SUBJECT: Duke Energy Corporation
McGuire Nuclear Station Units 1 and 2
Docket Nos. 50-369 and 50-370
Catawba Nuclear Station Units 1 and 2
Docket Nos. 50-413 and 50-414
RAI "Relief Request 99-GO-003"

REFERENCE: Duke Relief Request, dated May 4, 2000

Duke Energy Corporation (Duke) submitted Relief Request 99-GO-003, dated May 4, 2000. In followup teleconferences, the NRC staff requested additional information with respect to several issues in the relief request. In response to those questions, as listed below, Duke provides the following information.

Figure 1

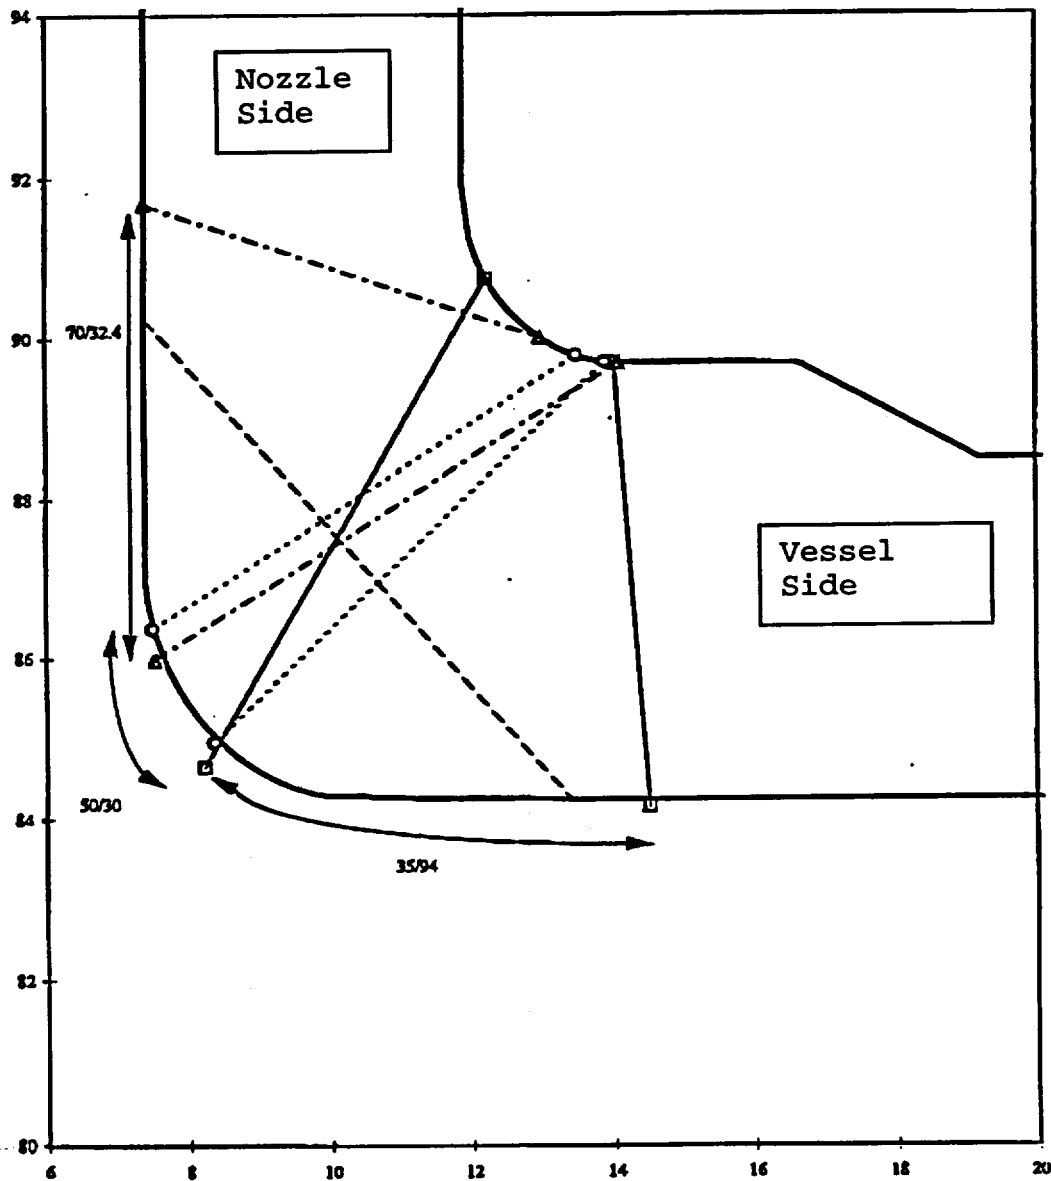
Explain the difference between preservice (8.4%) and inservice inspection coverage (100%)? Use sketches if necessary to show beam angles, skew angles, and scan directions.

Evaluation of the geometry during PSI showed that more coverage could be obtained from the outside blend radius of the nozzle. Duke Energy Corporation contacted the EPRI NDE Center staff for assistance in performing computer modeling and developing a scan plan for the feedwater nozzle inner radius. A new calibration block was also designed to duplicate the nozzle geometry using notches as calibration reflectors. This effort was completed in approximately three months. With the new scan plan, calibration block and new wedges 100% coverage can be obtained. The increased coverage was achieved using the following angles:

70° beam angle/32.4° skew

50° beam angle/30° skew

35° beam angle/94° skew

The coverage for each beam angle/skew combination is shown in Figure 1.

Figure 2

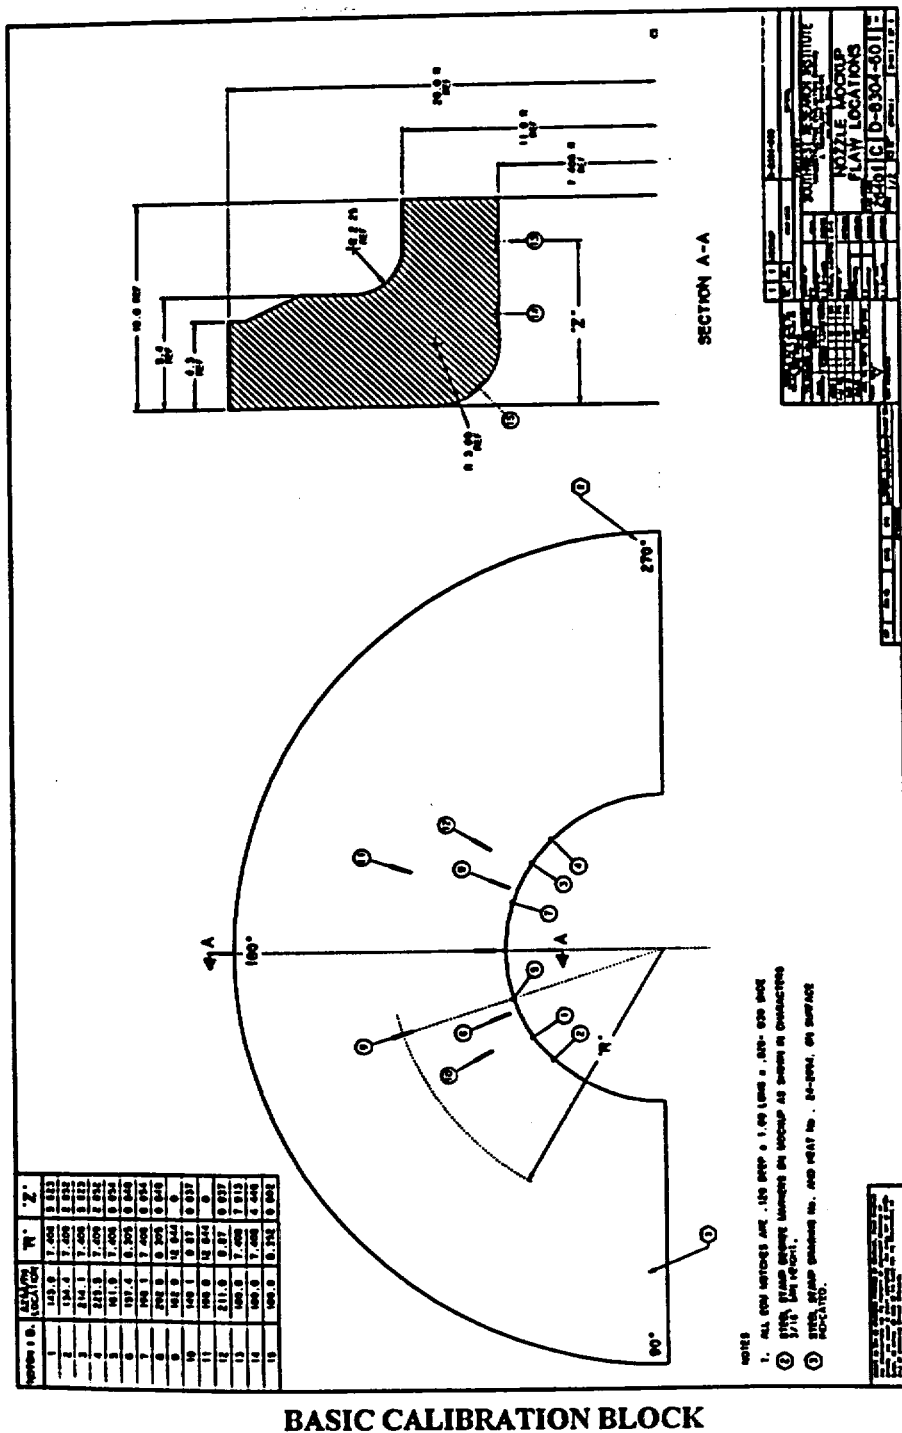
Explain the changes, if any, to the prescriptive requirements in Code that created the improvement in coverage to 100% (computer modeling, different beam angles, etc)?

The Basic Calibration Block described in T-441.1.1 was

not used. A calibration block that duplicated the ID and OD geometry was used to demonstrate coverage and for calibration. This calibration block uses only notches in lieu of side drilled holes. See Figure 2

Notches machined as shown in Figure 2 were used to establish sensitivity for the examination. No distance-amplitude correction was used.
